# HISTORIC AND DESIGN REVIEW COMMISSION

May 03, 2017

<b>HDRC CASE NO:</b>	<b>2017-187</b>
<b>ADDRESS:</b>	417 N OLIVE ST
<b>LEGAL DESCRIPTION:</b>	NCB 577 BLK 16 LOT A22 & A23
<b>ZONING:</b>	RM-4 H
<b>CITY COUNCIL DIST.:</b>	2
<b>DISTRICT:</b>	Dignowity Hill Historic District
<b>APPLICANT:</b>	John Holzmann
<b>OWNER:</b>	Mod Olive, LLC
<b>TYPE OF WORK:</b>	Installation of a prefabricated home, fencing and landscaping
<b>REQUEST:</b>

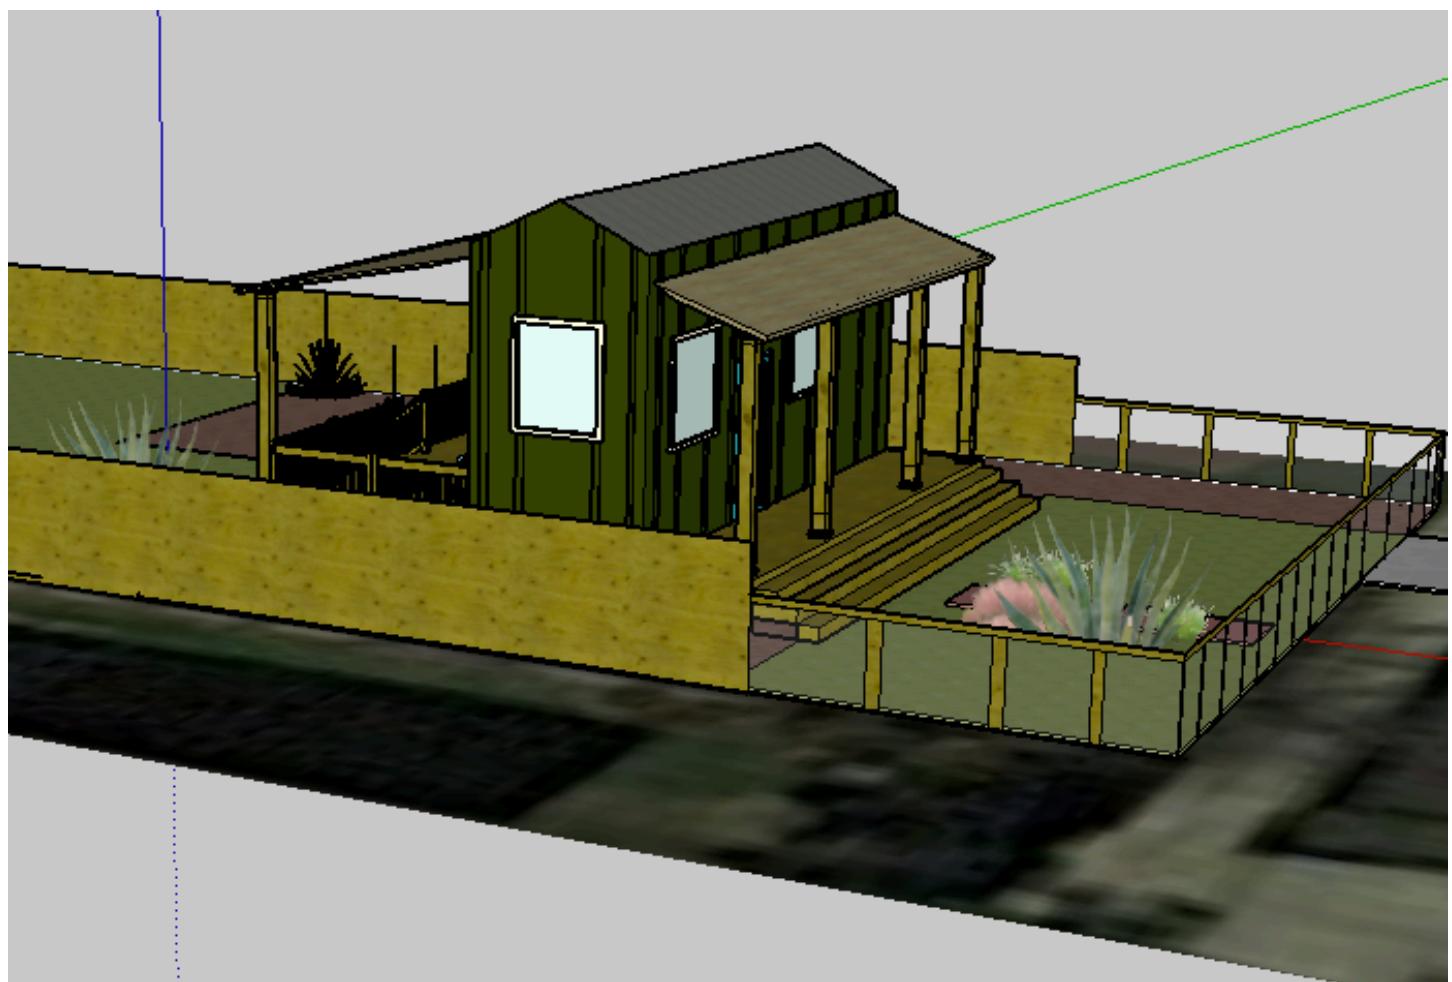
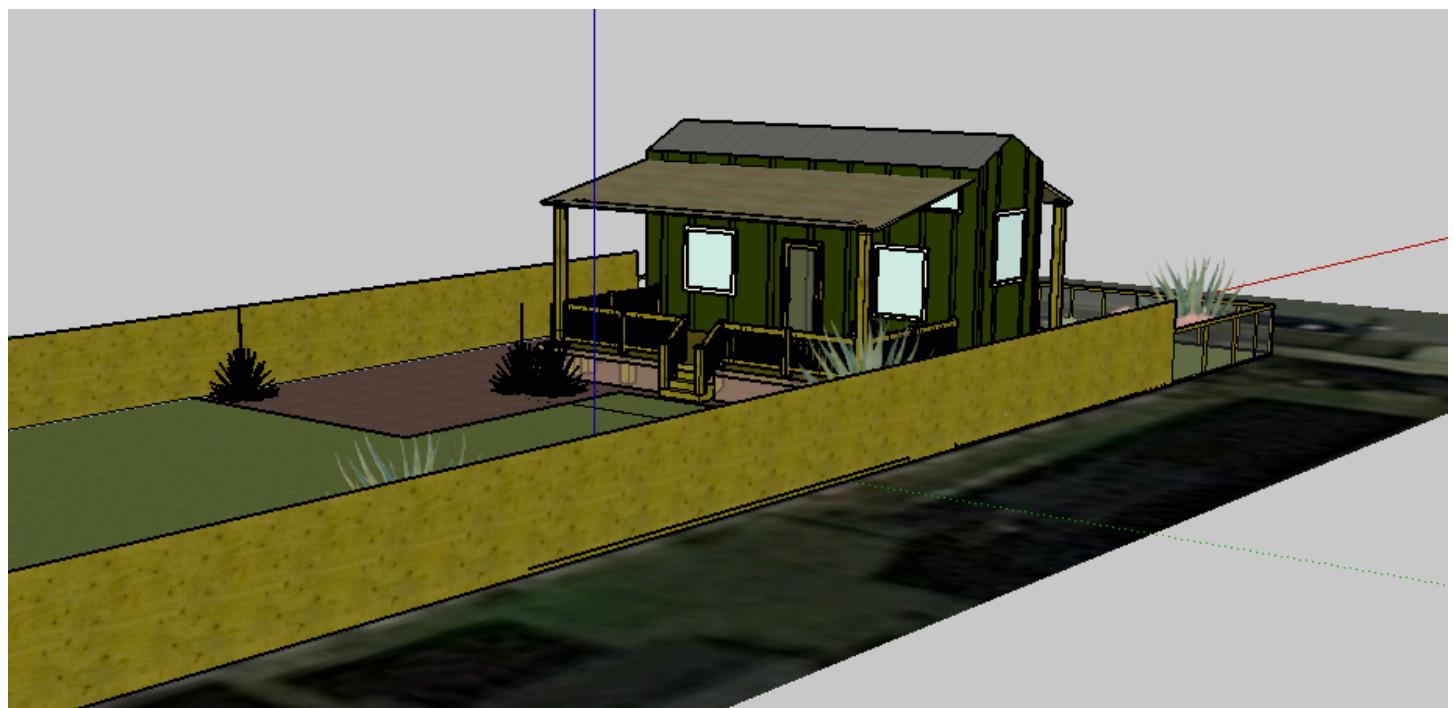
COMMENTS/CONCERNS: AN: SHED ROOF HAS BEEN CHANGED INTO

A GABLED ROOF. AMG: HOW WILL THE FOUNDATION BE SCREENED?

SKIRTING SHOULD BE USED. Q1: WILL THIS BE THE ONLY STRUCTURE

TO FLOOR DESIGN (FRONT + REAR), ~~AMG~~ ARE YOU REQUESTING CONCEPTUAL OR FINAL - MORE DETAILS ARE NEEDED.

DL: PROVIDE AN UPDATE SITE PLAN, PORCH DETAILS, SKIRTING MATERIALS, COLUMN DETAILS, ETC. PROVIDE INFORMATION WHEN REQUESTING CONCEPTUAL APPROVAL.

JF: COULD THE PORCH EXTEND THE FULL WIDTH OF THE FRONT / STREET FACING FAÇADE?

LF: PROVIDE SITE + LANDSCAPING PLAN, DETAILS ON DESIGNS.

DL: CONSIDER A HORIZONTAL SIDING OPTION AS WELL.

AH: VARIOUS DESIGN ELEMENTS CAN CHANGE, BUT THE OVERALL FOOTPRINT CANNOT CHANGE.
